TECHNICAL BULLETIN
TB-24-001

Title: Pole Guy Installation Standards Revision

Issue Date: 12/26/2024

Department: Distribution Standards and Materials

STANDARD NO. E-1-2 VERSION 2

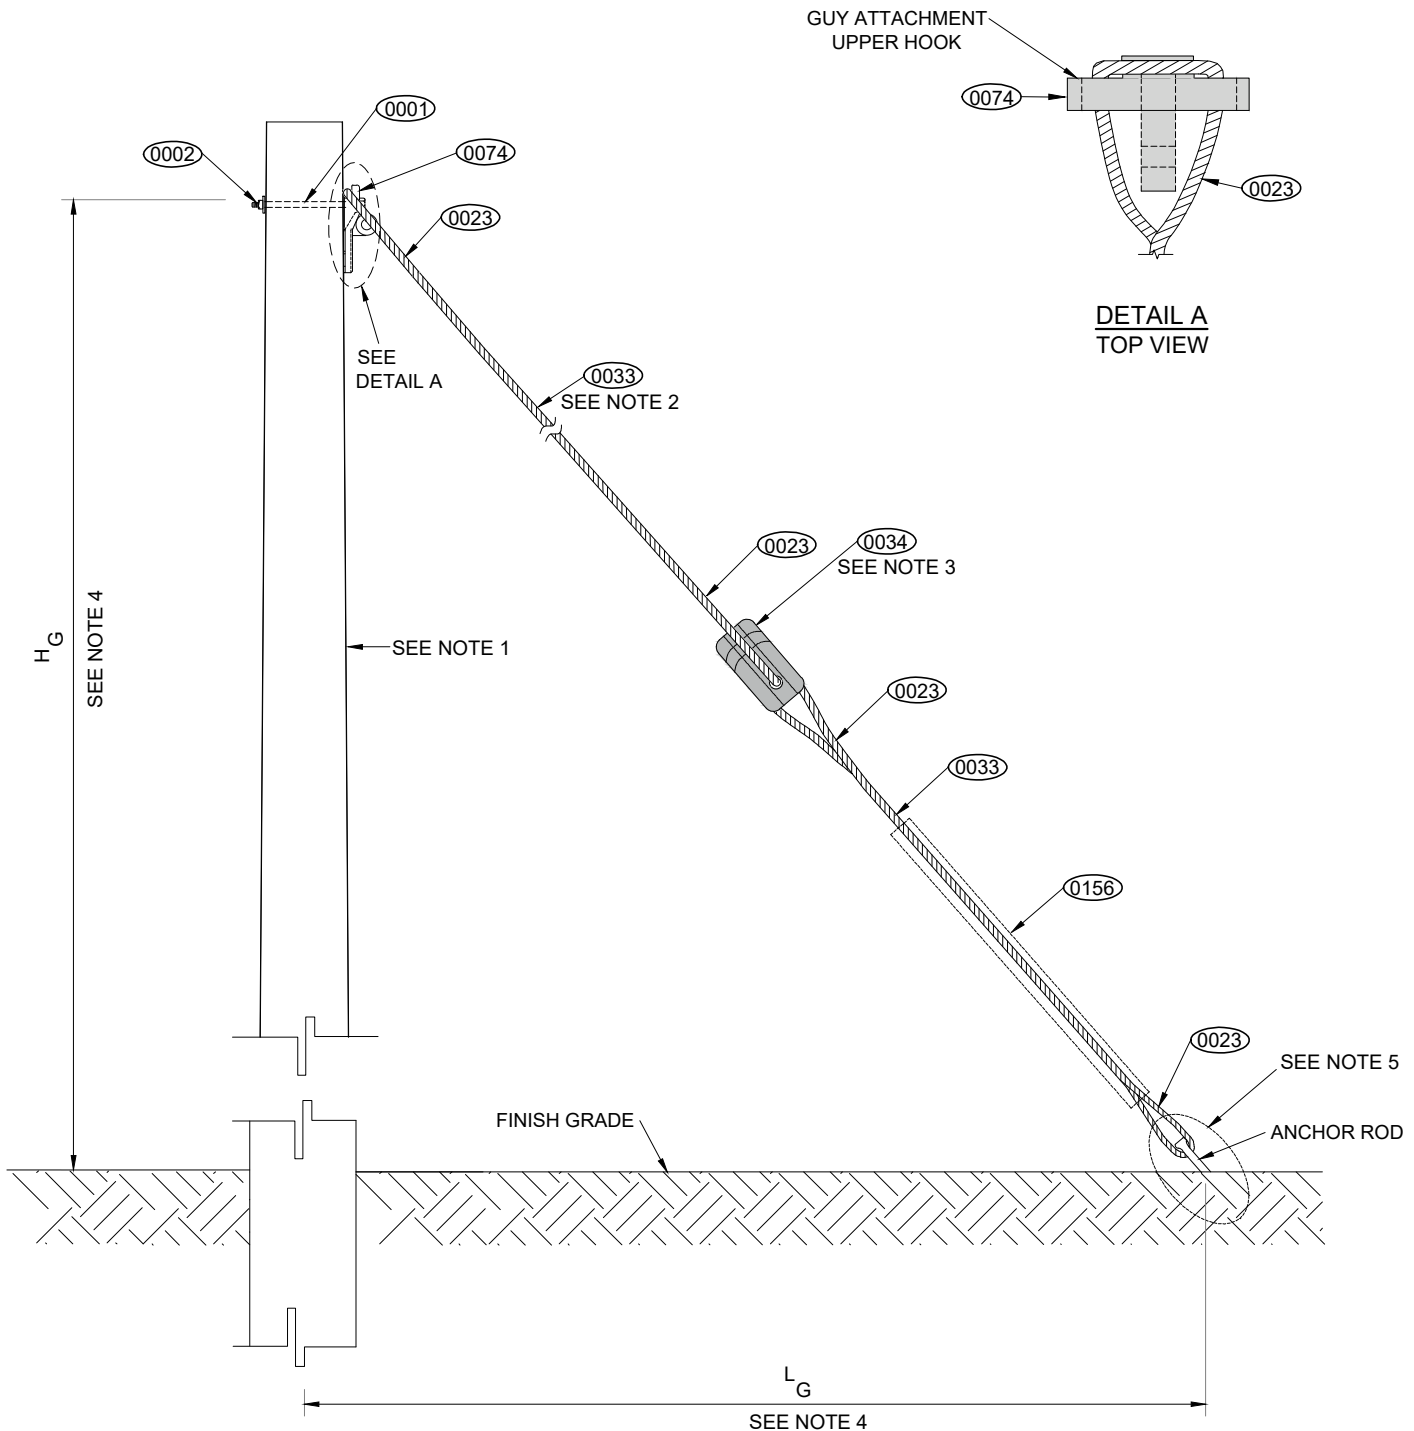
The Puerto Rico Electric Power Authority (PREPA) document *Manual de Normas de Distribución Urbana*, published in 1986, includes the standard no. E1-2, *Montaje de Tensor a Tierra Línea Secundaria*, dated September 10, 1985. This standard was used for pole guy installation without insulators when only secondary lines were installed on the pole. The use of this standard was discontinued when the Overhead Electrical Distribution System Manual (the Manual), version 1, was released on June 14, 2022, and version 4 of standard no. E-1-2-3 was adopted. A new evaluation on this matter was conducted, and it was decided to adopt version 2 of standard no. E-1-2, Pole Guy Installation for Secondary Lines, document no. 4301.172, exclusively for the installation of guys on poles with only secondary lines.

secondary lines. The capacity of the materials in standard no. E-1-2-3 exceeded the tension requirements for the installation of guys on poles with only secondary lines. For this reason, version 2 of standard no. E-1-2 was approved with the tension requirements for this type of installation. This change is expected to lead to a lower acquisition cost of materials compared to standard no. E-1-2-3.

- THIS STANDARD APPLIES TO THE INSTALLATION OF GUYS ON POLES SUPPORTING ONLY SECONDARY LINES.
- THE LOAD SHALL BE EQUAL TO OR LESS THAN 90% OF THE GUY WIRE BREAKING STRENGTH.
 - 3/8" DIAMETER GUY WIRE:
RATED BREAKING STRENGTH IS 10,800 LB. LOAD SHALL NOT EXCEED 9,720 LB.
- THE QUANTITY OF PORCELAIN GUY STRAIN INSULATORS (ITEM 0034) REQUIRED TO PROVIDE ELECTRICAL ISOLATION AND SUPPORT FOR GUY WIRES SHALL BE DETERMINED BY THE ENGINEER TO ENSURE THAT, IF A GUY WIRE SLACKENS OR BREAKS, NO PART OF IT, UP TO A HEIGHT OF 8'-0" ABOVE THE FINISH GRADE, CAN BECOME ENERGIZED.
- REFER TO STANDARD NO. E-5 FOR DETAILS ON THE SELECTION OF GUYS.
- REFER TO THE APPLICABLE GUY ANCHORING INSTALLATION STANDARDS NO. F-1-3, F-5-1, OR F-6-1.

FIGURE 1
INSTALLATION WITH GUY ATTACHMENT (36,000 LB)

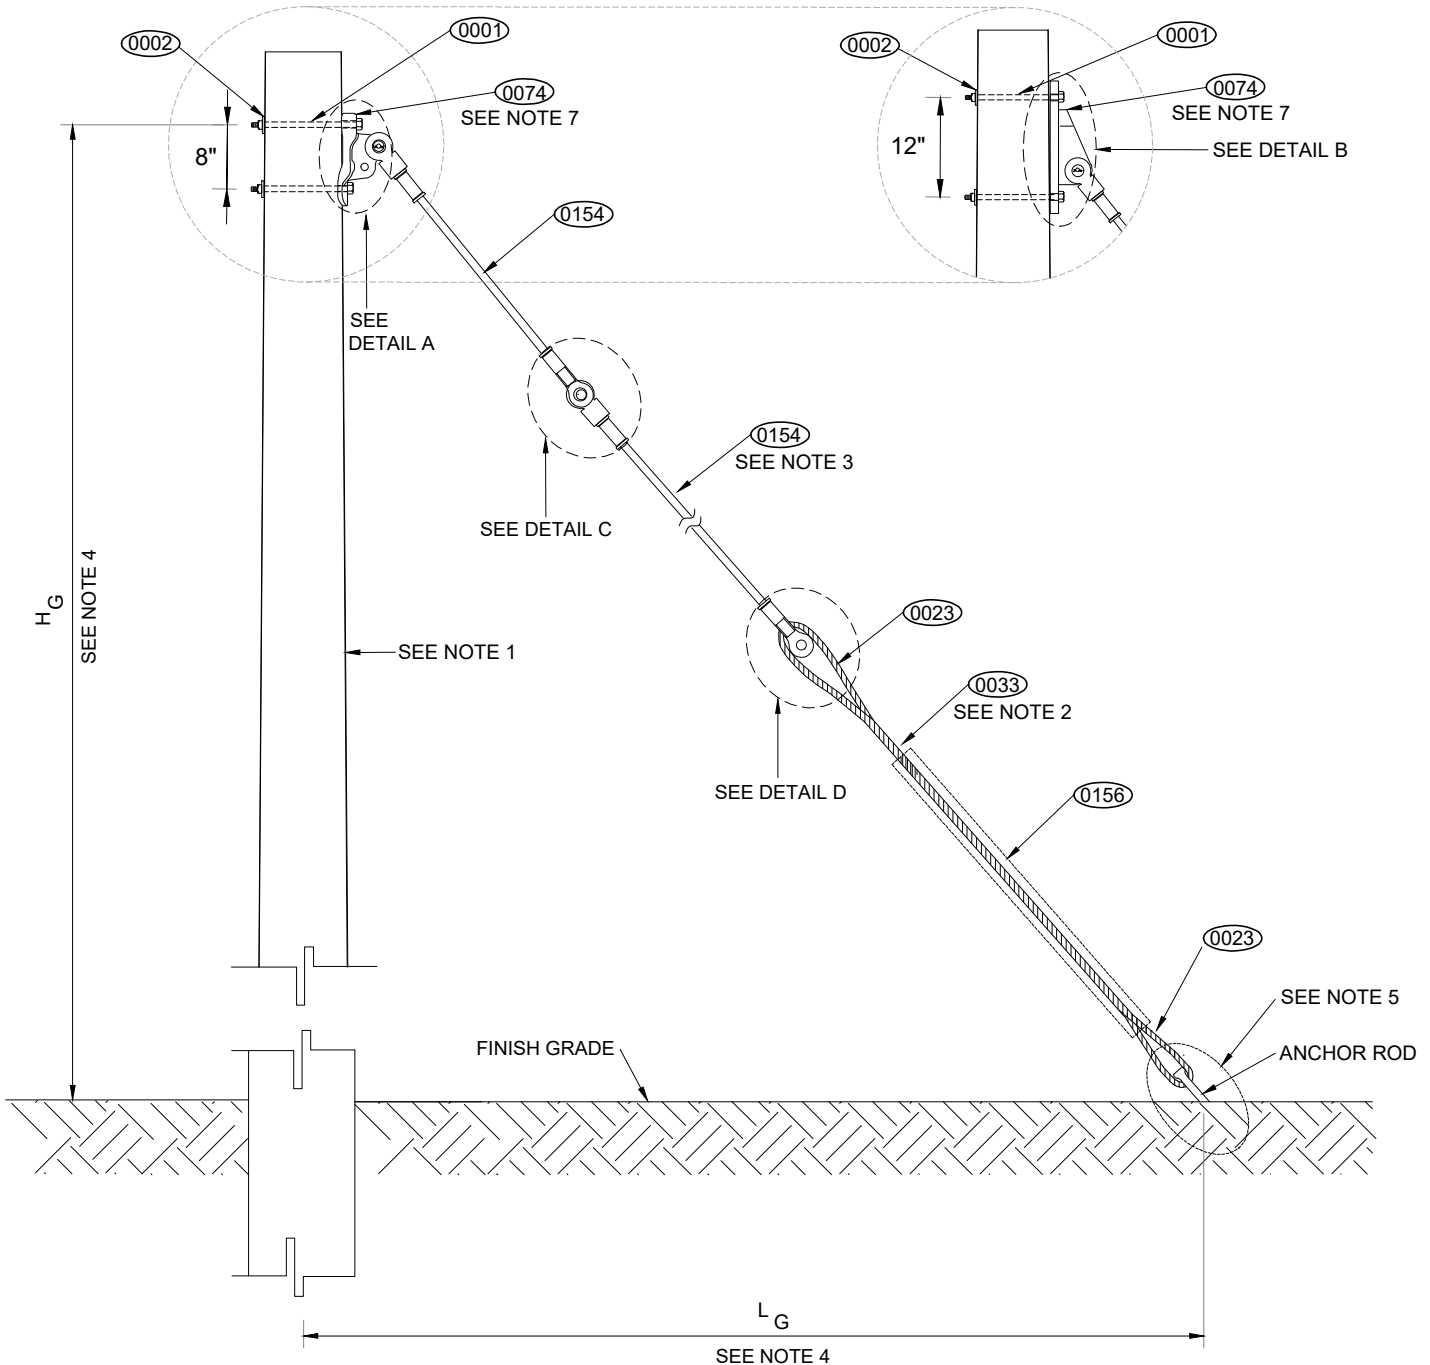
As a result, version 5 of standard no. E-1-2-3, Pole Guy Installation, document no. 4301.083, dated January 23, 2024, which was used for guy installation on poles with primary, secondary, or both primary or secondary lines, will no longer be used for poles that support only

Additionally, the guy attachment shown in standard no. E-1-2-3 has been replaced with two guy attachment alternatives that have the necessary capacity for primary lines: one attachment has 8-inch spacing between its holes, while the other has 12-inch spacing. This modification ensures that installations are suitable for any required pole face on poles with primary or both primary and secondary lines. Furthermore, as explained, this updated standard will no longer be used for poles with only secondary lines but will be applicable to poles with primary lines or both primary and secondary lines.

- THE GUY ATTACHMENT (ITEM 0074) SHALL BE SELECTED ACCORDING TO THE POLE FACE SPACING OPTION CHOSEN FOR ITS INSTALLATION.

STANDARD NO. E-2-1 VERSION 4
DOCUMENT NO. 4301.085
PAGE 1 OF 3 DATE DEC 26, 2024
SUBMITTED LUIS R. SOTO LIC. 11658
REVIEWED IVETTE D. SANCHEZ LIC. 13837
APPROVED RICARDO CASTRO LIC. 12135
DIGITIZED EMILIO CUADRADO LIC. 3000

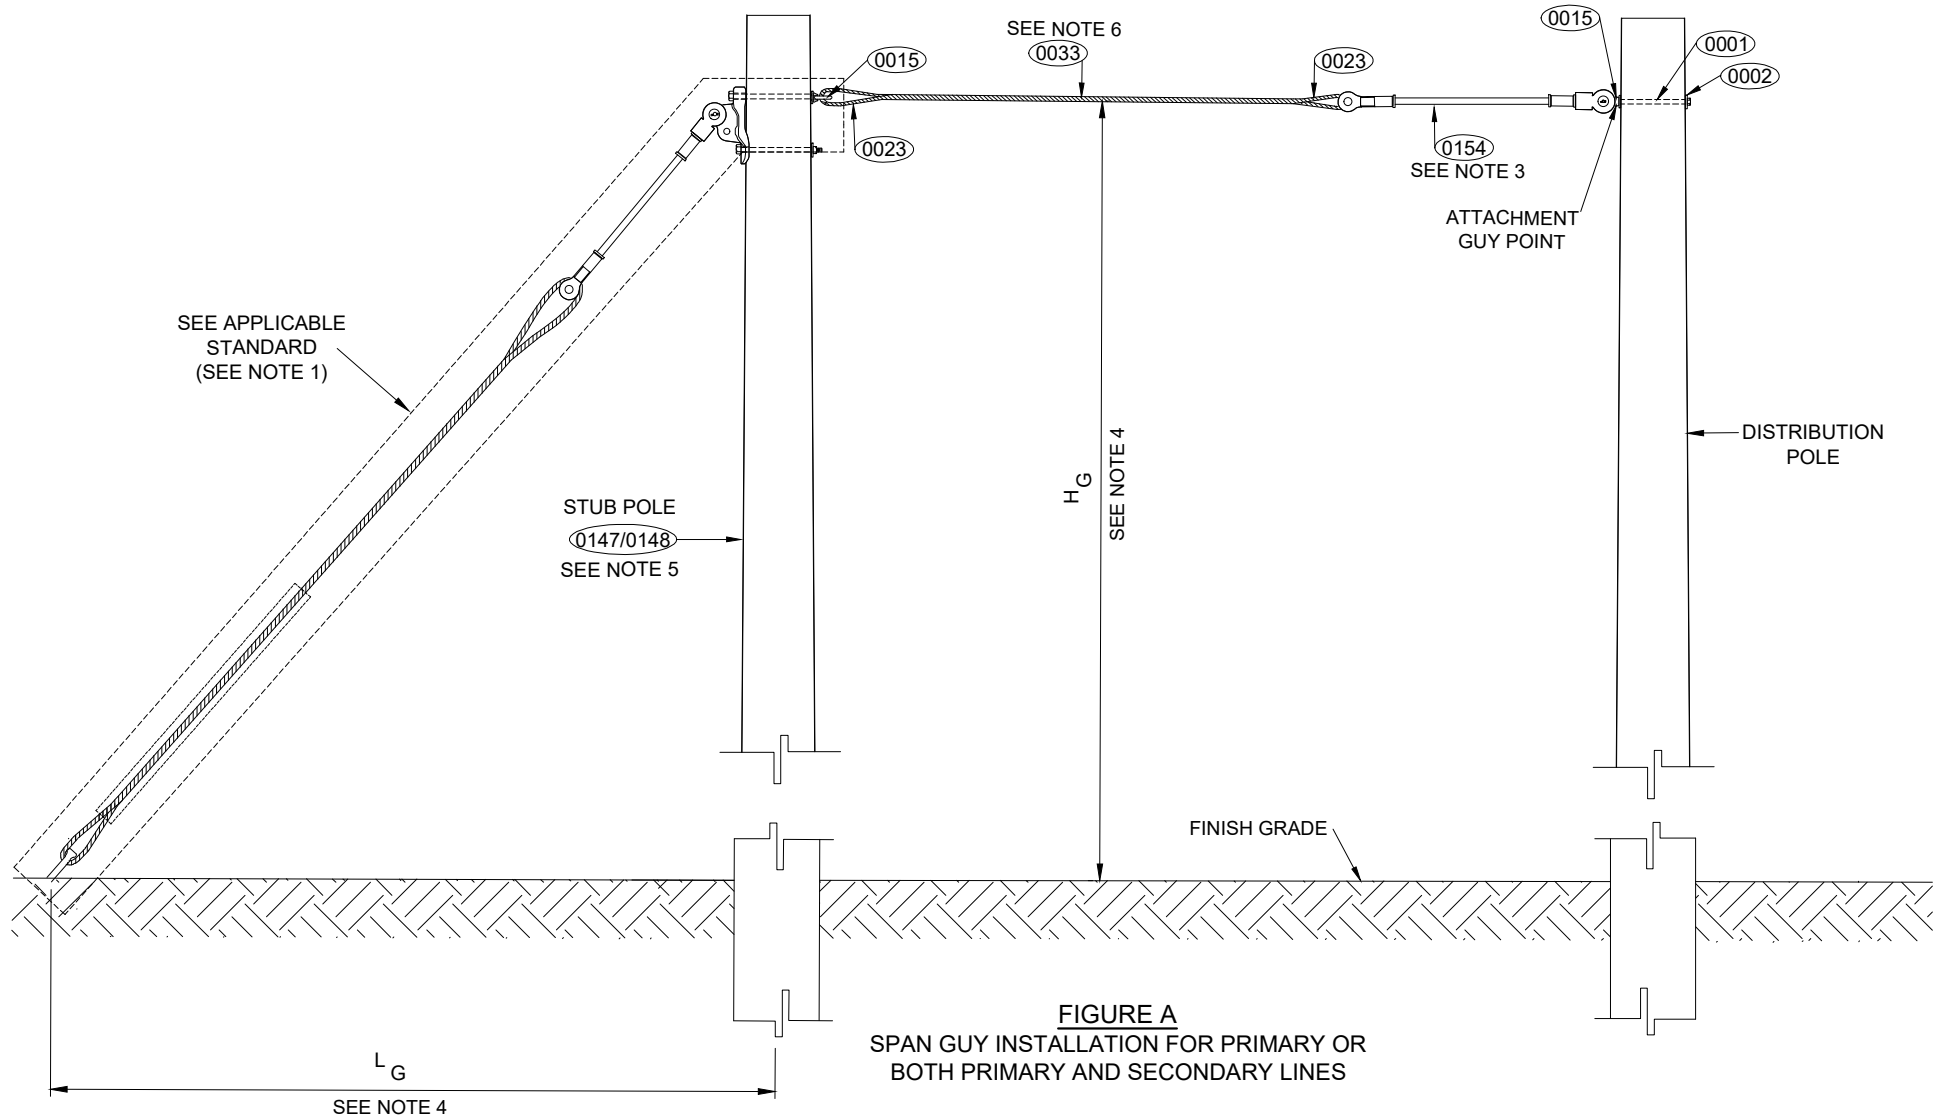
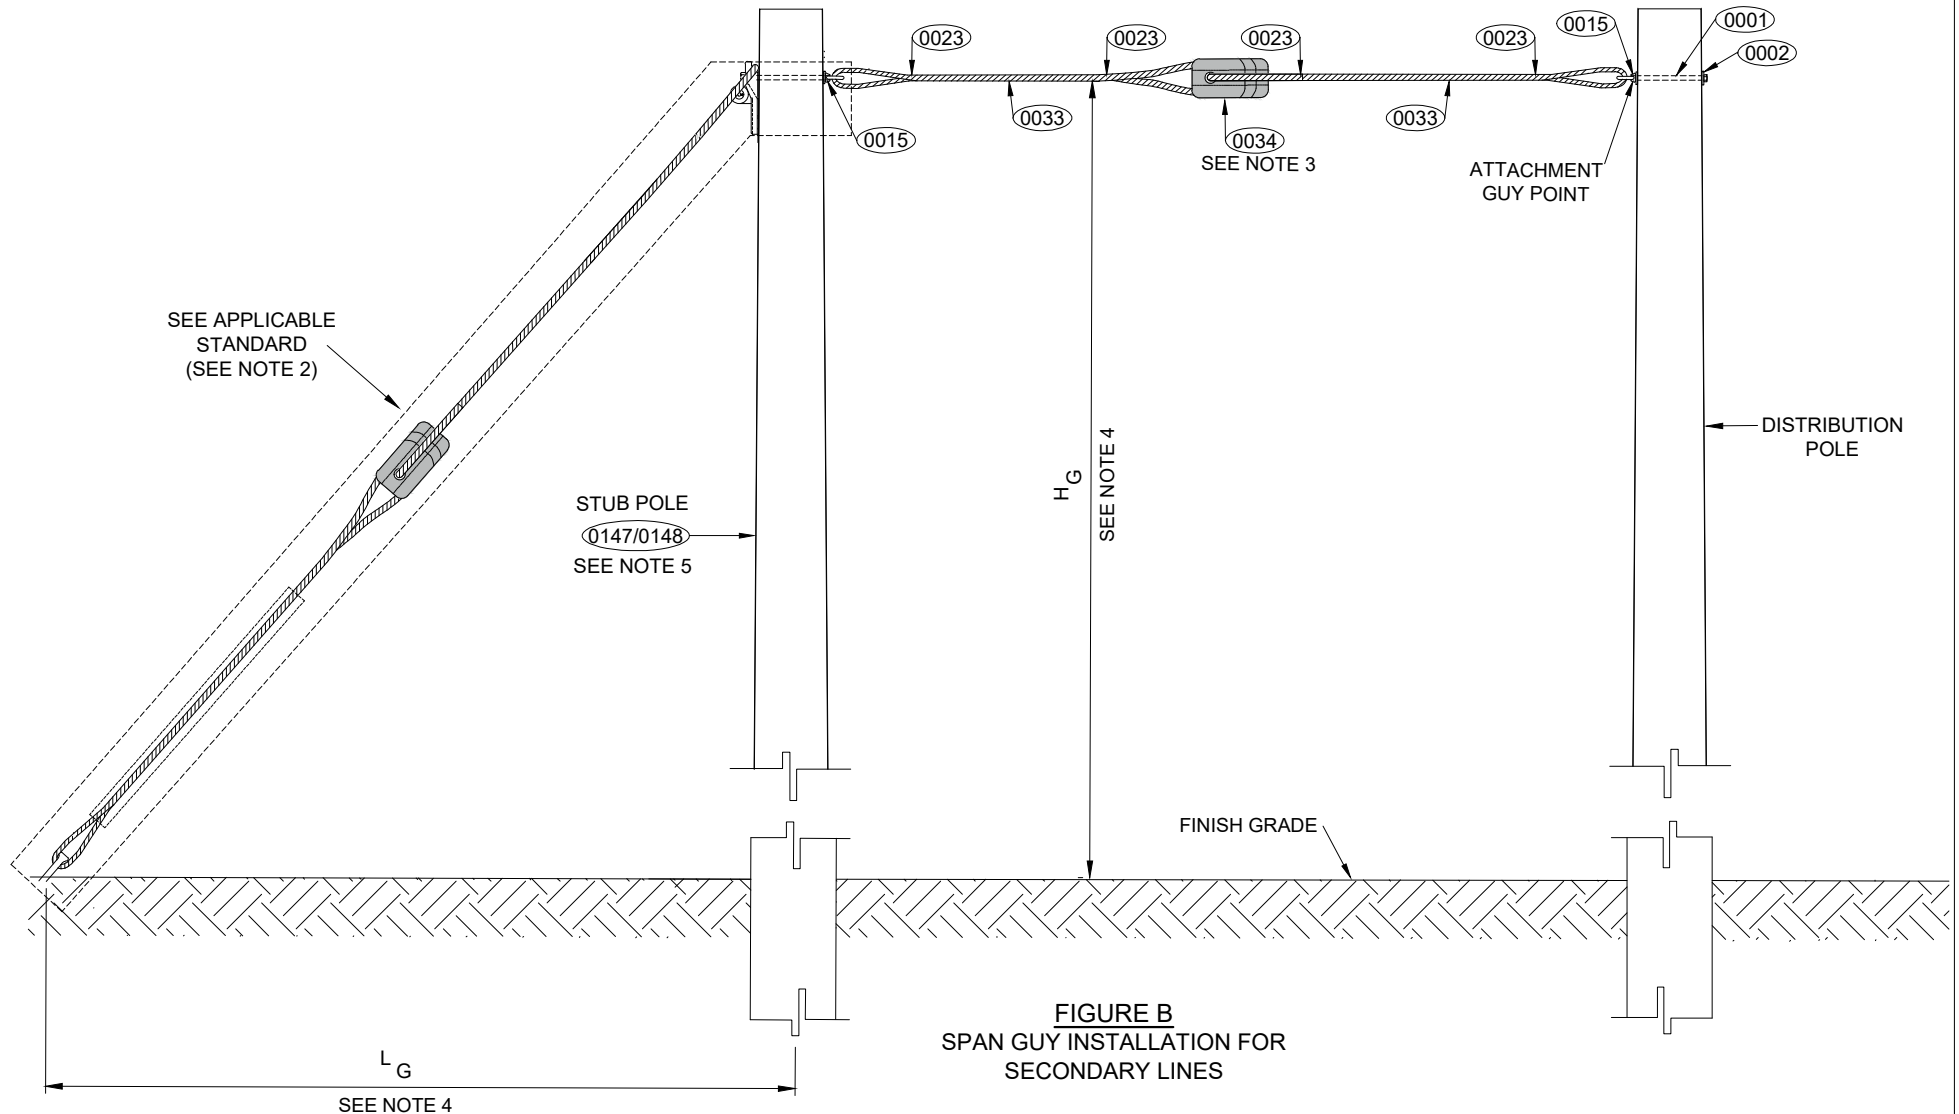
Version 5 of the Manual incorporated version 3 of standard no. E-2-1, Span Guy Installation, document no. 4301.085, dated January 23, 2024. This standard was used for span guy installation on poles with primary, secondary, or both primary and secondary lines. The addition of standard no. E-1-2 required modifications to the materials of standard no. E-2-1. Furthermore, the new version of standard no. E-2-1 specifies that the installation of the guy attached between the stub pole and the finish grade for poles with only secondary lines shall follow standard no. E-1-2. The guys for poles with primary or both primary and secondary lines will be installed in accordance with the updated standard no. E-1-2-3. Consequently, standard no. E-2-2, *Montura Para Tensor de Poste a Poste Línea Primaria*, included in the PREPA document *Manual de Normas de Distribución Urbana*, published in 1986, is being cancelled and substituted by the revised standard no. E-2-1.

1. REFER TO STANDARD NO. E-1-2-3 FOR DETAILS ON GUY INSTALLATION AND THE MATERIALS REQUIRED FOR POLES SUPPORTING PRIMARY LINES OR BOTH PRIMARY AND SECONDARY LINES.

2. REFER TO STANDARD NO. E-1-2 FOR DETAILS ON GUY INSTALLATION AND THE MATERIALS REQUIRED FOR POLES THAT SUPPORT ONLY SECONDARY LINES.
3. THE QUANTITY OF GUY STRAIN INSULATORS REQUIRED TO PROVIDE ELECTRICAL ISOLATION AND SUPPORT FOR GUY WIRES SHALL BE DETERMINED BY THE ENGINEER TO ENSURE THAT, IF A GUY WIRE SLACKENS OR BREAKS, NO PART OF IT, UP TO A HEIGHT OF 8'-0" ABOVE THE FINISH GRADE, CAN BECOME ENERGIZED.
